SQS ACTION ITEM LIST (V-3405)

: Borstar Bay3

: 236910-BAY3-31010 & 236910-BAY3-31000

: Repairs & Coating of Jacketed Vessels

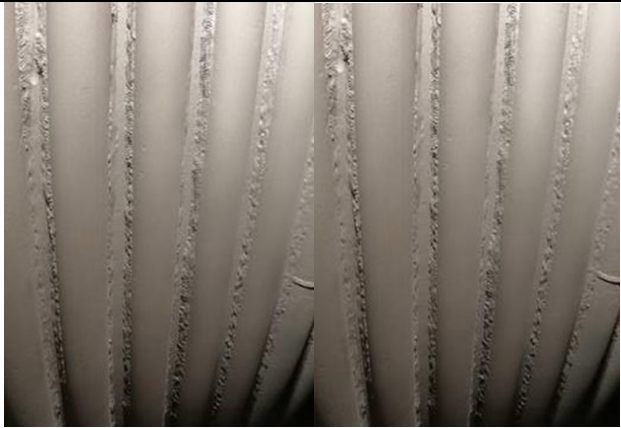
2.	(MATL)	16-Mar-2021	FR#31	<p>@ V3304A: Shell External Surface Mechanical Damages (Dent) has been found on the below location of Half tube surfaces. 4th Half Tube from the Head- Approximately 1 mm depth at one location @ 45° Orientation</p> 	<p>PT dent surfaces and perform pneumatic test to check the mechanical integrity which is approved by client dated 13-April- 2021. Test pressure : 721 psig.</p> <p>Areas to be tested are 4th half tube from dish head Mechanical Damages (Dent) observed location at orientation 45°.</p>	QICL	30-Mar-2021	Closed	<p>QICL provided dent length:</p>  <p>QICL Performed the PT on the above identified locations and test results confirmed the no surface defects and found satisfactory. Reports# QICL /J915 /PT/ 3304A/ 03 & QICL /J915 /VIR/ 3304A/ 04 reviewed and Endorsed.</p> <p>Pneumatic test has been performed and found satisfactory.</p>

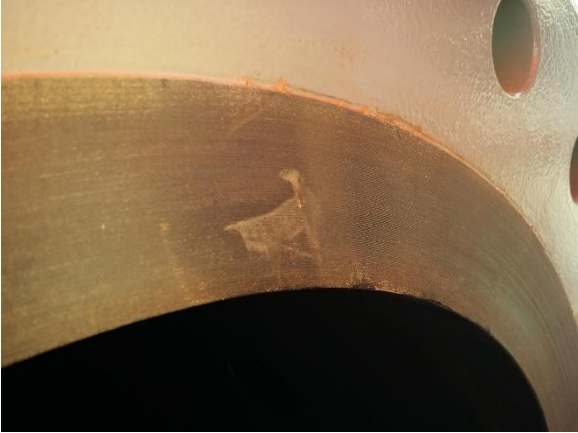
6.	(MATL)	16-Mar-2021	QICL-VIR-01	<p>Mechanical Damage observed on one location at Half Pipe no#2 from man way M2 at orientation 0° to 270°</p> 	Grind and PT, and recheck pipe thickness, 6 mm minimum.	MHI/QIC L	30-Mar-2021	24-Mar-2021	FR#37	<p>Action by QICL:</p> <p>1.QICL Performed the UT verification on the Identified Location (Before Grinding) and actual thickness found in the range of 7.5 to 7.6 which is above the required minimum thickness (6mm). Thickness report # GPTI-UTG-6183 was reviewed and Endorsed.</p> <p>2.QICL Performed the UT verification on the Identified Location (After Grinding) and actual thickness found in the range of 7.3 to 7.6 which is above the required minimum thickness (6mm). Thickness report # GPTI-UTG-6184 was reviewed and Endorsed.</p> <p>3.QICL Performed the PT on the above grinded surface and test results found satisfactory. Report# QICL/J915/PT/3304A/02 reviewed and Endorsed.</p>
